**Report: ISSUE REPORT
Function: Test, Adjust, & Balance
Date: 02/08/2024**

**PROJECT
02-05-24 PERRY'S - VERNON HILLS, IL**

Issue List

Speedtaps
02/08/2024

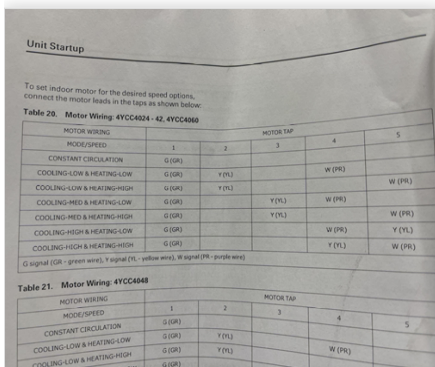
Issue Name : RTU-4: High on airflow
Description : RTU-4 is multispeed unit scheduled for 600cfm with speed taps. Plans call for constant volume. Unit is within design at Speed tap 1, where G is landed. Manual indicates placing W(heat) at 4 and Y (cool) at tap 2, puts heating and cooling to low speed, this is 940cfm. Not possible to wire all stages to same speed. No indication if jumpers are allowed.

RTU_5
02/08/2024

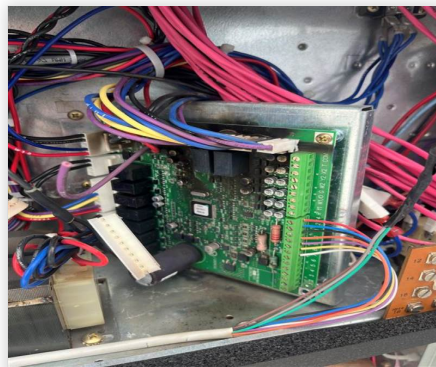
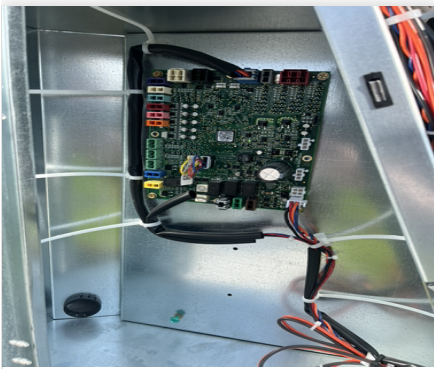
Issue Name : RTU-5: Not Operational
Description : RTU-5 is not operational as the control board is fried. Waiting on replacement board. Unit not yet balanced as result.
Created By : National TAB **Assigned To :** National TAB - Michael McDonnell
Status : Open
Priority : Urgent **Asset Tag :**
Originated Date : 02/08/2024 - Michael McDonnell - National TAB
